Display

Date: **June 4, 2001**

Subject: **SPIKE NOISE IN H BLANKING**

Model: **BVM-D20F1A, *BVM-D20F1E*,
 BVM-D20F1U, BVM-D24E1WA
BVM-D24E1WE, BVM-D24E1WU
 BVM-D32E1WA, *BVM-D32E1WE*
 BVM-D32E1WU**

Figure 1

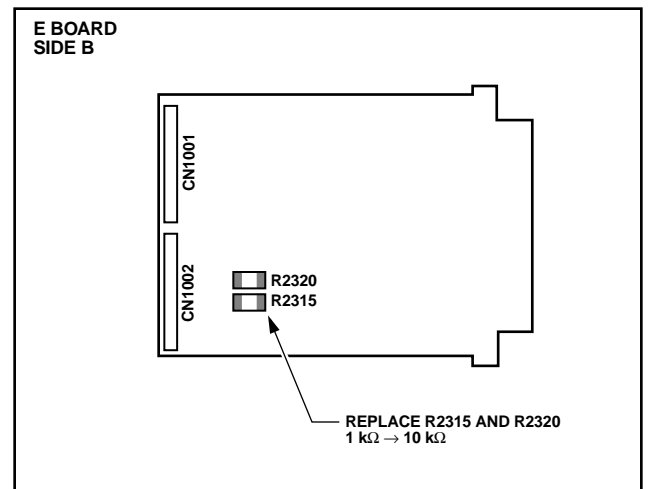
When under-scanned in 1080/60I and 1035/60I mode, spike noise may appear at the left and right in H blanking, appearing to move up and down.

**E Board, Side B
 (See Figure 1.)**

1. Remove the shield plate from the E board.
2. Replace R2315 and R2320 (1 kΩ) with new 10 kΩ resistors.
3. Reinstall the shield plate.
